Seattle Pacific University

Major Institution Master Plan (MIMP) Preliminary Draft EIS

DAC Comments on the Prelim Draft EIS

Figure 3.5-8
Viewpoint Location Map

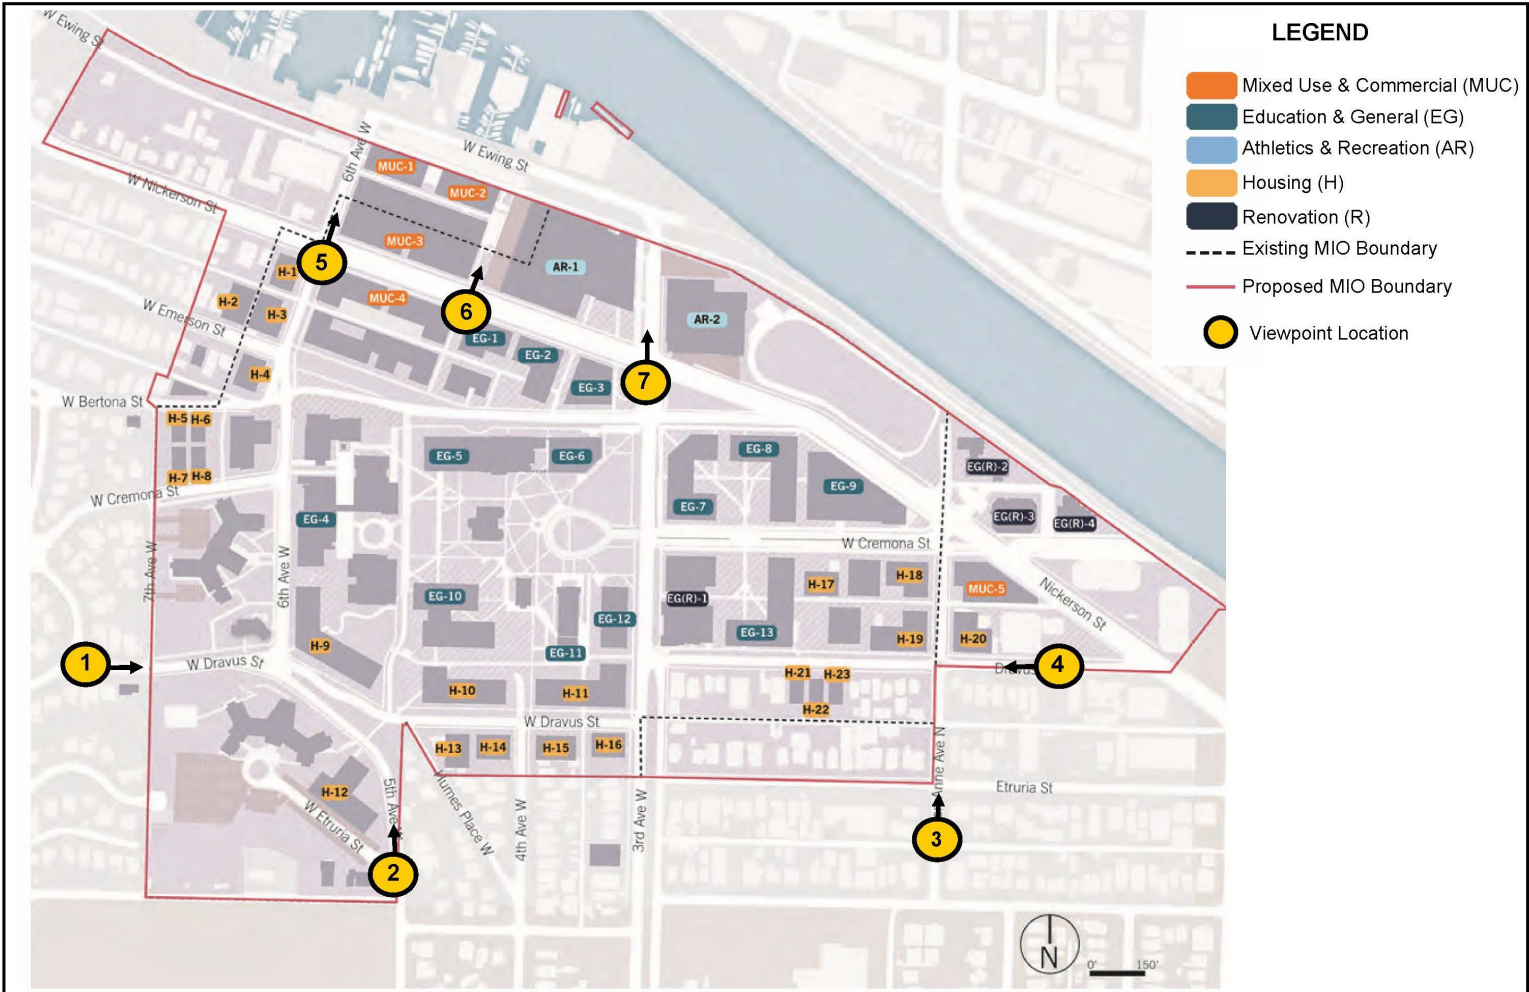
2.	The proposed MIO boundaries increase all MIO-50 to MIO-65. Impacts on properties adjacent to the MIO boundary, specifically around the southwest portion of campus (7th Avenue W including W Cremona St., W Dravus St., and W Barrett St., and 5th Ave W between W Barrett St. and W Dravus St.) need to be analyzed. Mitigation measures, such as extending the MIO-37 buffer, and including landscape buffers, building setbacks, and buildings stepping up, need to be considered to create adequate transitions from the campus to these properties.	The CAC commented that views in this area are important, especially looking north, and listed one or two specifically. For example, Preliminary DEIS Figure 3.5-2 shows a proposed 6-story residence hall to the southeast of Ashton Hall (see page 3.5-9). This is one area that should include view studies: 1) From the west at the point in the 700 block of West Etruria Street (above the fence at the east end of the street) where the new building would be most visible; and 2) from the east/southeast, where there are nearby lowrise and single-family homes. As noted during the one of the CAC meetings, the depiction of the view from Dravus and 8th Avenue West, showing the top 2-3 floors of a new dorm building west of 6 th Avenue West, does not appear to be accurate.

Response: Additional viewshed photosimulations have been prepared for the Draft EIS and include views from the following locations:

- at 8th Ave. W. and W. Dravus St., looking east toward the SPU campus
- from the intersection of 5th Avenue W and W Eutruria Street looking north
- looking north from Queen Anne Avenue N, in between W Etruria Street and W Florentia Street
- view looking west from W Dravus Street, near its intersection with Queen Anne Avenue N

Result: As demonstrated in the Viewshed Figures on the following slides, the overall visual character from these viewpoints would change to include larger, taller buildings visible on the SPU campus. However, in most cases, street corridors and open areas/landscape screening would separate the new development from low-rise residential homes present in the vicinity and no significant impacts would be anticipated.

Several potential development projects are proposed in the Shoreline District within and adjacent to the Northwest MIO Expansion area (Buildings MUC-1, MUC-2 and AR-1). Three view photosimulations are provided and demonstrate that views of the water (where available) would not change significantly under the **Draft MIMP**. Shoreline view photos were taken from the following locations:

- W Nickerson St. at the intersection with 6th Ave. W, looking north
- W Nickerson St. at a mid-way point in between 6th Ave. W and 3rd Ave. W, looking north
- W Nickerson St. at the intersection with 3rd Ave. W, looking north

Figure 3.5-8 provides the locations of these viewpoints across campus.

Viewpoint 5—W Nickerson and 6th Ave. W, Looking North

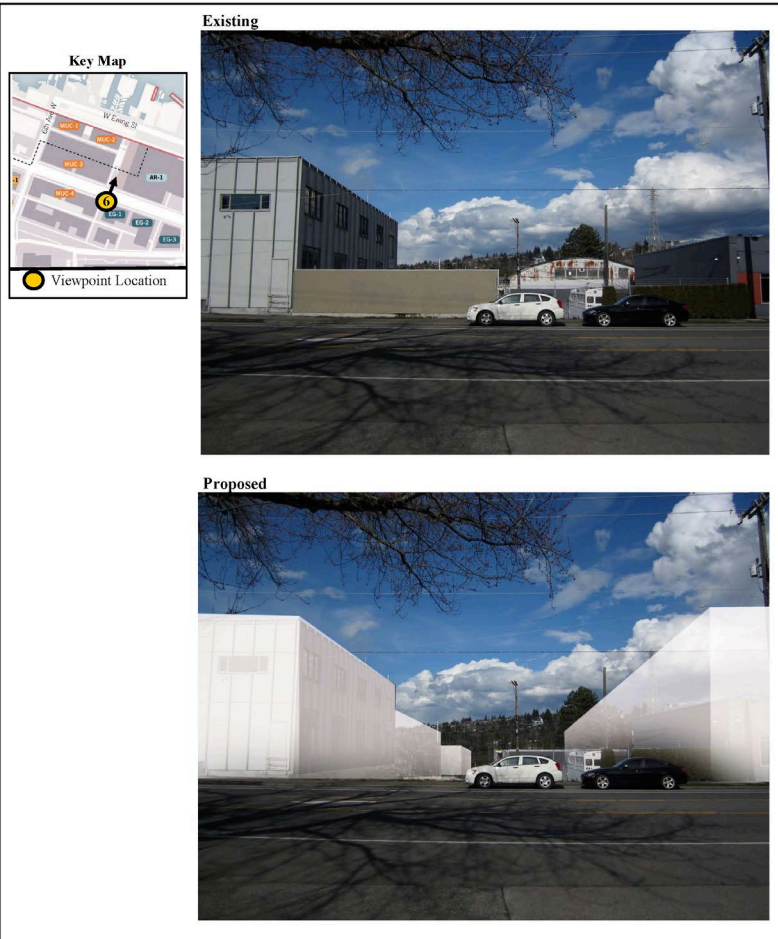
1.	Analyze the impacts of orienting development on W. Nickerson St. toward the South Ship Canal Trail.	The CAC has not seen any analysis of this in the PDEIS but expects that the impacts will be addressed in the DEIS.
<p><u>Response:</u> Design Guidelines included in the Draft MIMP for <u>A. Site Planning</u> include the following:</p> <ol style="list-style-type: none"> How does the design locate entrances at prominent intersections and pathways? How does the design encourage human activity on the ground plane? How does the design encourage and support pedestrian and bicycle activity? <p>Design Guidelines included in the Draft MIMP for <u>D. Pedestrian Environment</u> include the following:</p> <ol style="list-style-type: none"> How does the design incorporate convenient, attractive, well-lit, and protected pedestrian entries? <p>Design Guidelines included in the Draft MIMP for <u>Athletics and Recreation</u> include the following:</p> <ul style="list-style-type: none"> Athletics and Recreation buildings that front a public right-of-way should be designed with sensitivity to the pedestrian scale along sidewalks and paths with the use of detailing, unit-based expression of materials, and/or wall openings. <p>These design guidelines will be included, and impacts analyzed in the <i>Land Use Plans and Policies</i> section of the Draft EIS.</p>

Existing and
Proposed Height
Limits

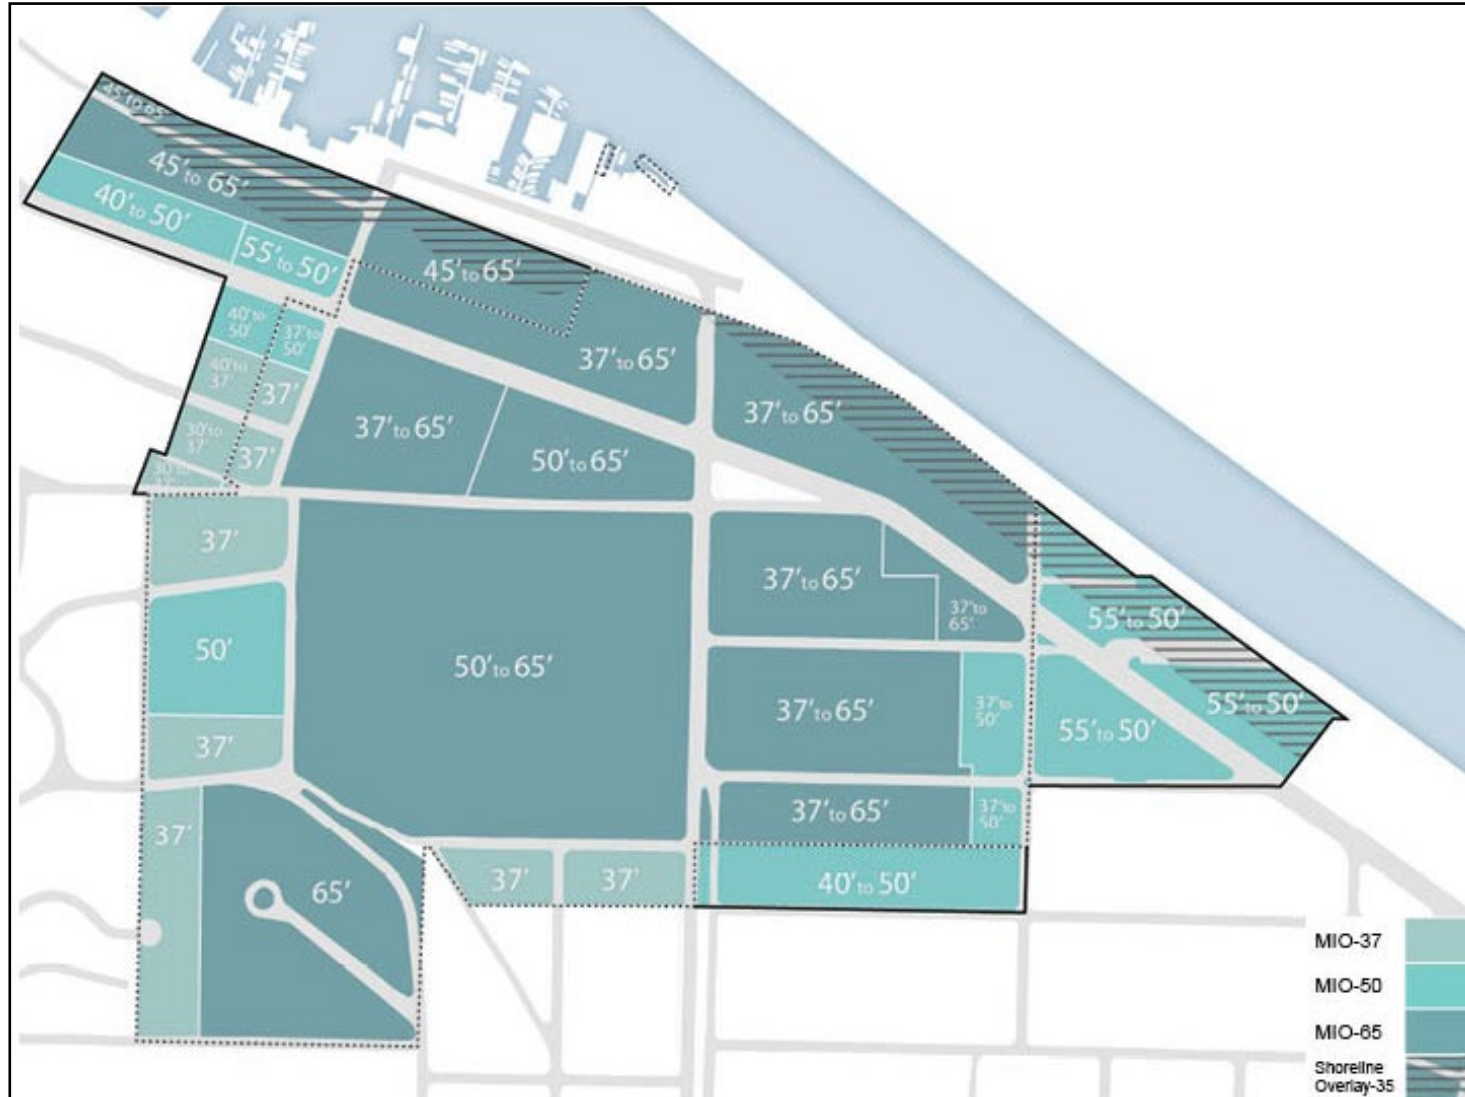
3.	There are significant topographic changes on campus and the surrounding neighborhood. Consequently, the taller campus zoning heights will impact surrounding properties differently, depending on where each sits on the high and low points of the slope. For example, the area south of Hill Hall sits at the high end of the valley and should be assigned a lower building height.	In the cross-sectional analysis noted in the highlighted text on page 3.5-9, include E-W partial cross-sections that cut through the west campus MIO-50 (designated as area 11 in the MIMP) and the MIO-37 and MIO-65 (designated as areas 16 and 17 in the revised MIMP) to demonstrate that the height transitions are appropriate to the adjacent slopes.
<u>Response:</u> the <i>Draft MIMP</i> reduced the proposed MIO height in areas 16 and 17 from 65 feet to 50 feet, thereby substantially reducing the potential impact to off-campus residential neighborhoods adjacent to these areas on campus. Additional cross-sections were, therefore, not prepared for these areas.
